**STAFF REPORT**  
**COMMUNITY DEVELOPMENT DEPARTMENT**

SUBJECT: H-2022-0013  
Promenade Cottages Subdivision

LOCATION: 403 E. Fairview Ave., in the NW 1/4 of Section 7, Township 3N, Range 1E.  
(Parcel #S1107212707)

B. Preliminary Plat (dated: 4/7/2023)

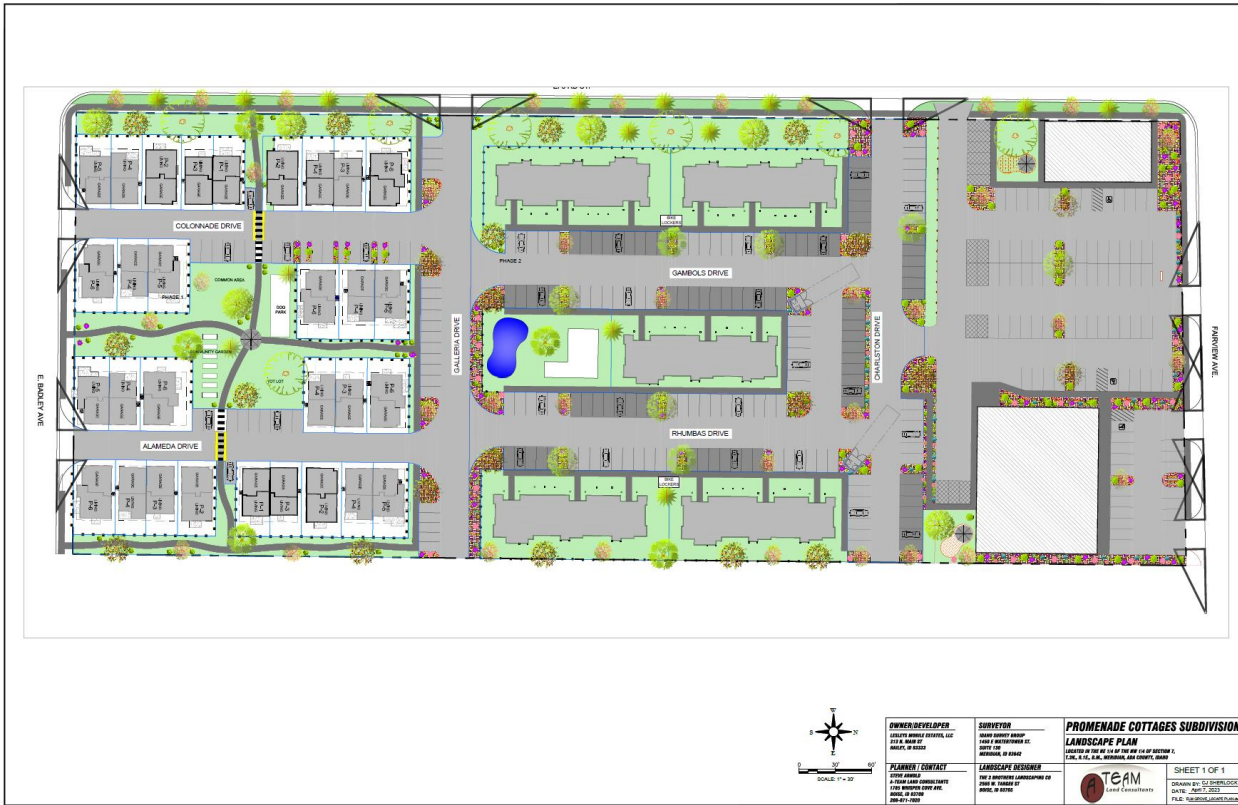
- b. Remove the western-most driveway access driveway via E. Fairview Ave. on the commercial portion of the property as it does not meet ACHD policy.

- c. Remove one of the two driveway accesses via E. Fairview Ave. in front of the existing multi-tenant building in accord with UDC [11-3A-3](#), unless otherwise waived by City Council.

- f. Delineate the privates from parking areas on the common lot.
- 2.2 The landscape plan included in Section VII.C shall be revised as follows:
- a. Depict a 25-foot wide street buffer along E. Fairview Ave., an arterial street, and a 20-foot wide street buffer along NE 3<sup>rd</sup> St., to be improved as a collector street, with landscaping in accord with the standards listed in UDC [11-3B-7C](#).

C. Landscape Plan (date: 4/7/2023)

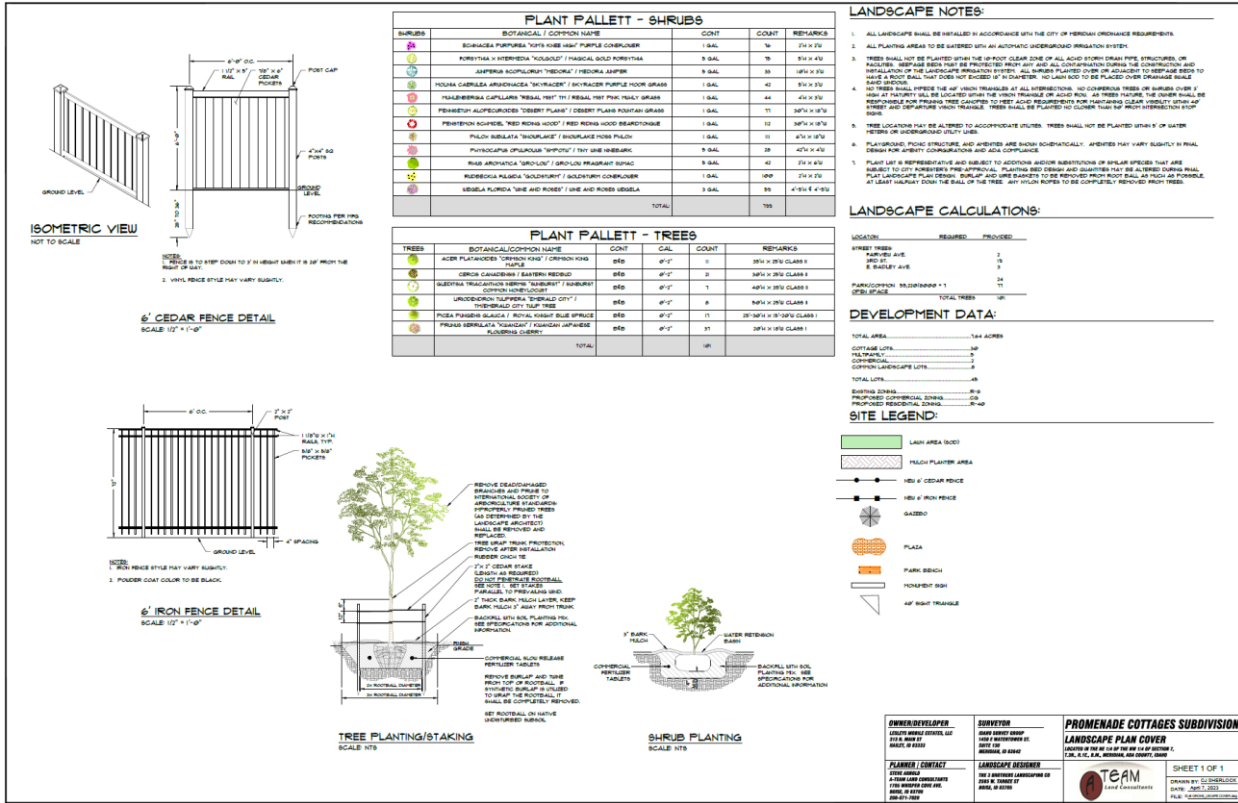
- b. Landscaping is required adjacent to all pathways within the site in accord with the standards listed in UDC [11-3B-12C](#).
  - c. Mitigation information should be included on the landscape plan for all existing trees that are being removed with development in accord with the standards listed in UDC [11-3B-10C.5](#).

- d. Depict a minimum 5-foot wide detached sidewalk with an 8-foot wide parkway along the east side of NW 3<sup>rd</sup> Street in accord with the Downtown Meridian Street Cross-Section Master Plan (see pg. 4-11).
